# ADDENDUM NUMBER 1

- 1.01 DATE: 04.25.2022
- 1.02 PROJECT: FOLEY PRIDE POCKET PARK
- 1.03 OWNER'S PROJECT NUMBER: ENGR-042622B
- 1.04 OWNER: CITY OF FOLEY
- 1.05 LANDSCAPE ARCHITECT: WAS DESIGN, INC.
- TO: PROSPECTIVE BIDDERS:
- 2.01 THIS ADDENDUM FORMS A PART OF THE CONTRACT DOCUMENTS AND MODIFIES THE ORIGINAL PROCUREMENT DOCUMENTS DATED 04.08.2022, WITH AMENDMENTS AND ADDITIONS NOTED BELOW.
- 2.02 ACKNOWLEDGE RECEIPT OF THIS ADDENDUM IN THE SPACE PROVIDED IN THE BID FORM. FAILURE TO DO SO MAY DISQUALIFY THE BIDDER.
- 2.03 THIS ADDENDUM CONSISTS OF 5 PAGES AND THE FOLLOWING DRAWINGS:

#### Re: Foley Pride Pocket Park - RFI responses to questions received in writing, Addendum 01

LF100

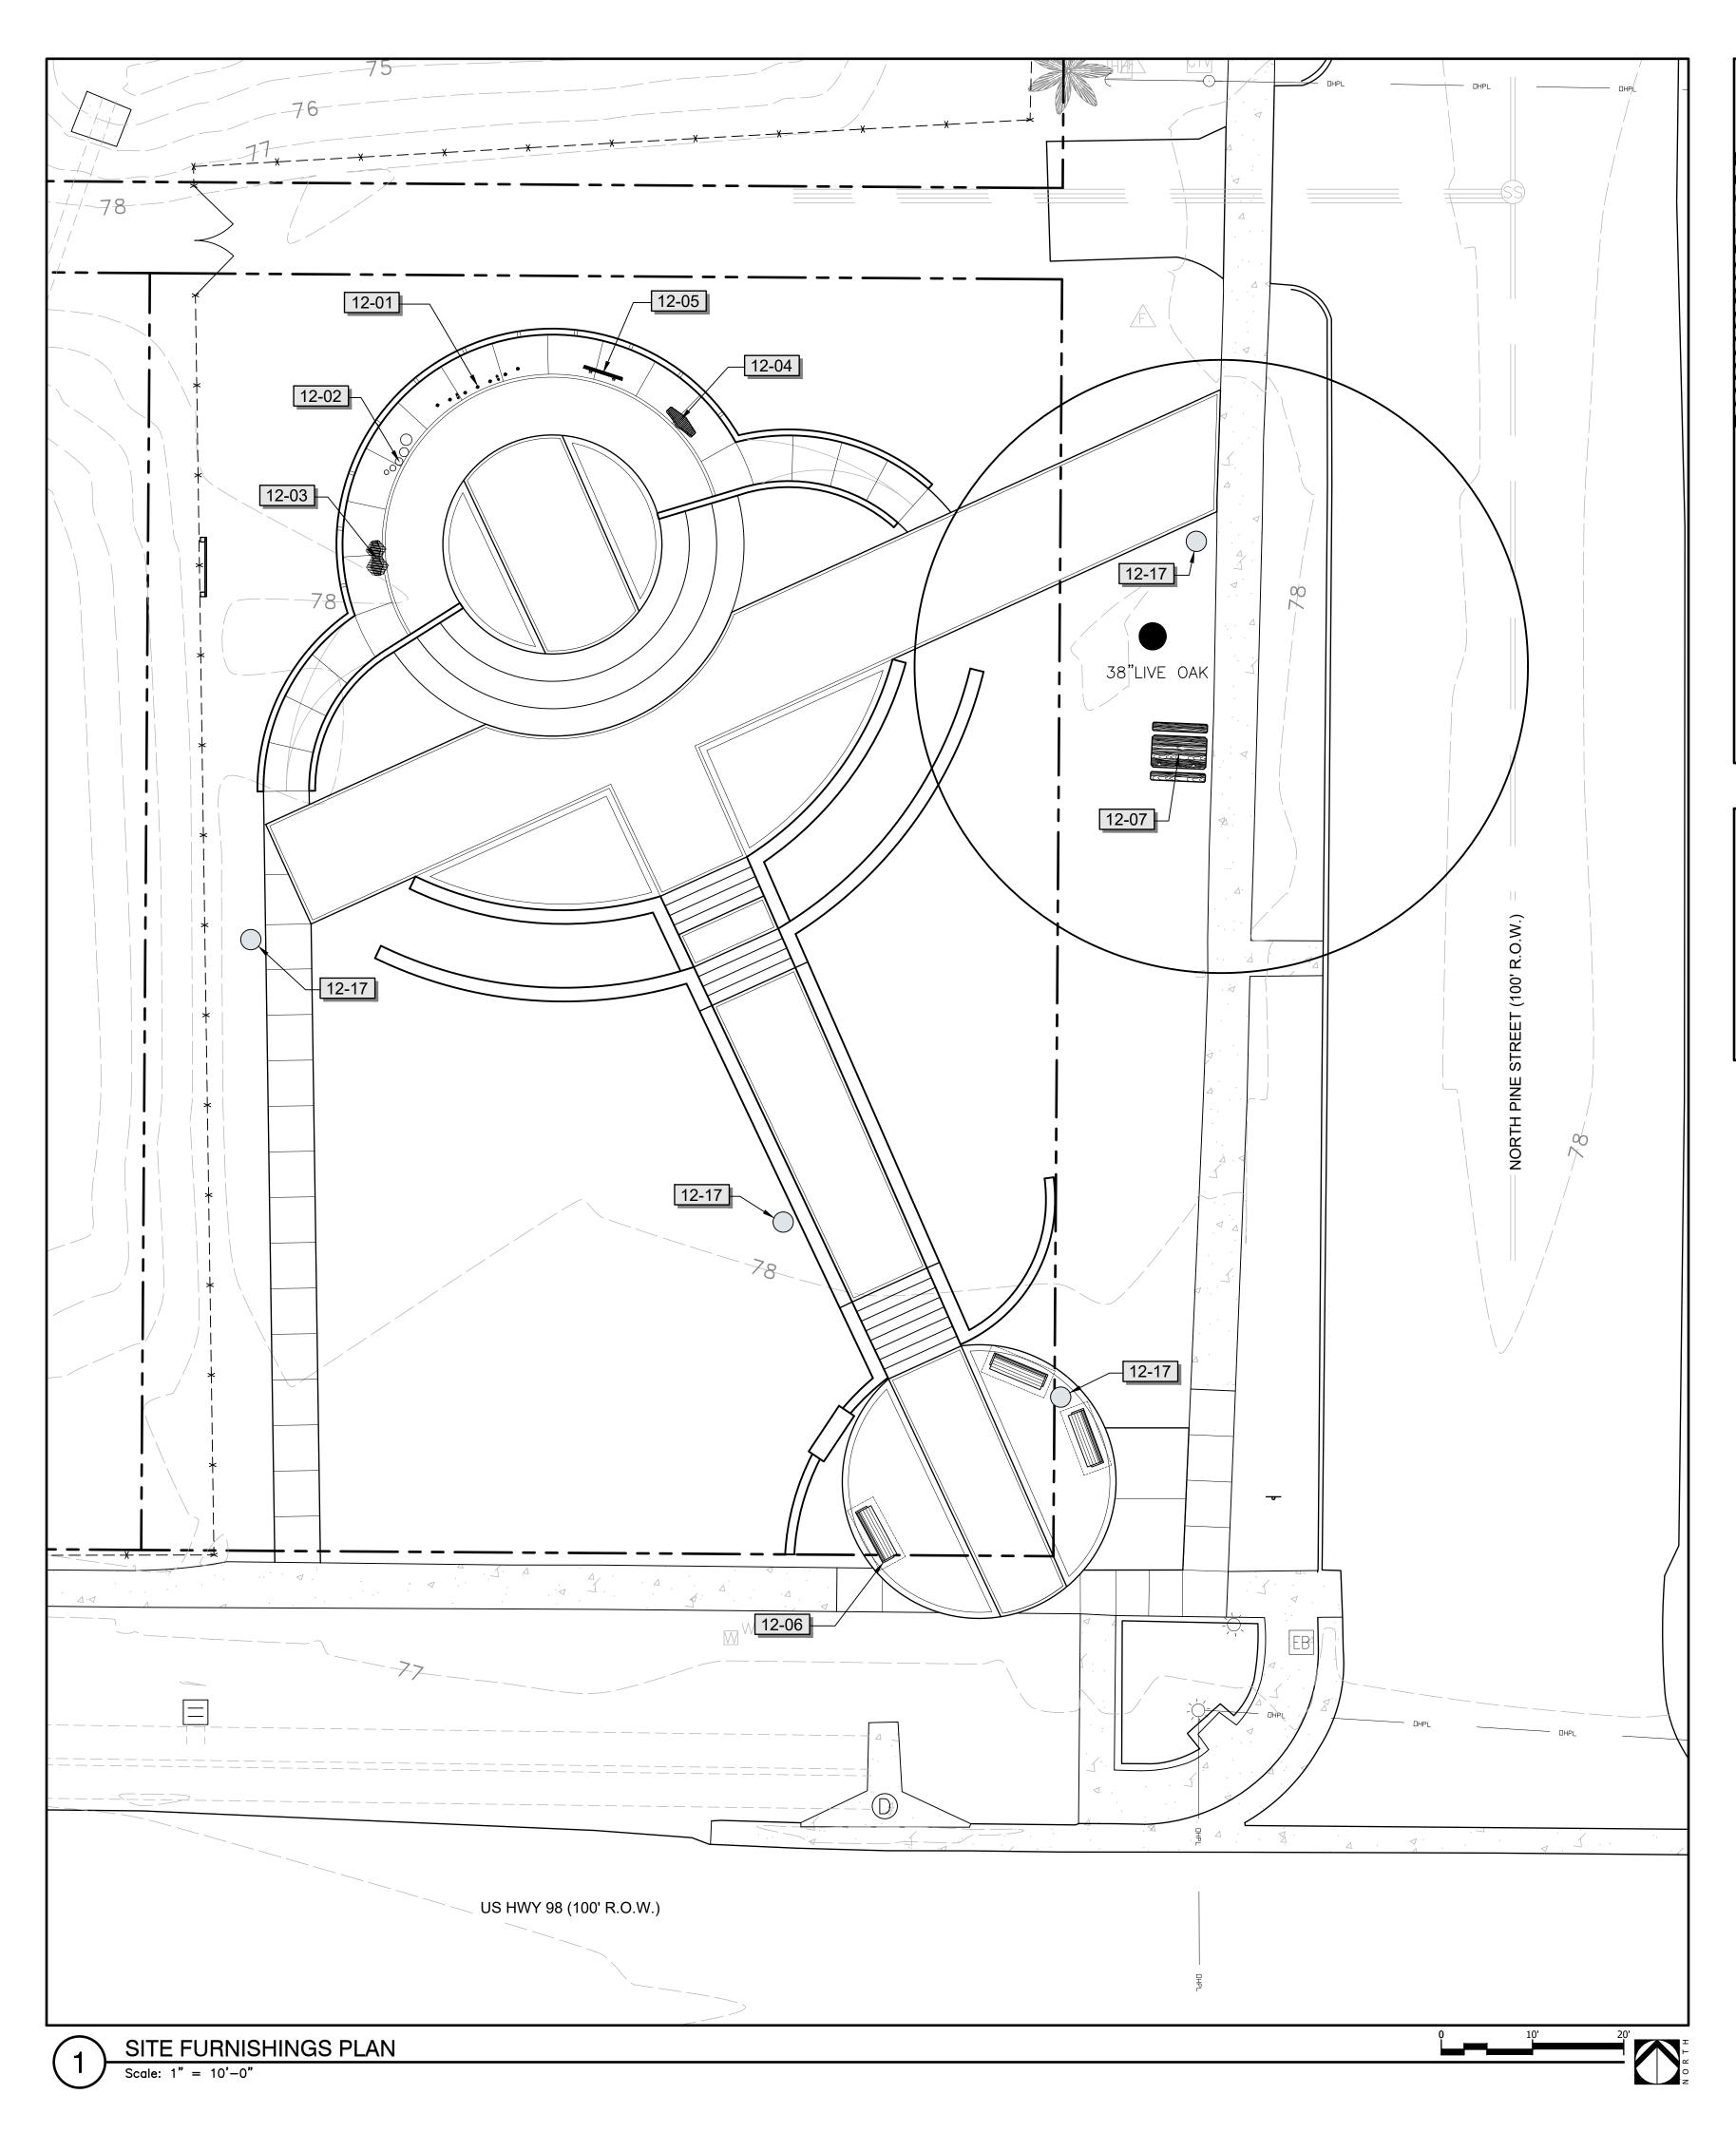
- 1) Is the GC responsible for the entrance signage?
  - a) No, the signface and lighting will be provided & installed by the owner. The GC is responsible for building the wall and providing conduit as detail 1/LH502 has shown.
- 2) Are all of the harmony park instruments to be in ground or surface mounted?
  - a) All Harmony Park instruments shall be surface mounted per the manufacturer's recommendations. The stage concrete has been increased to 6" to comply with the manufacturer's installation detail.
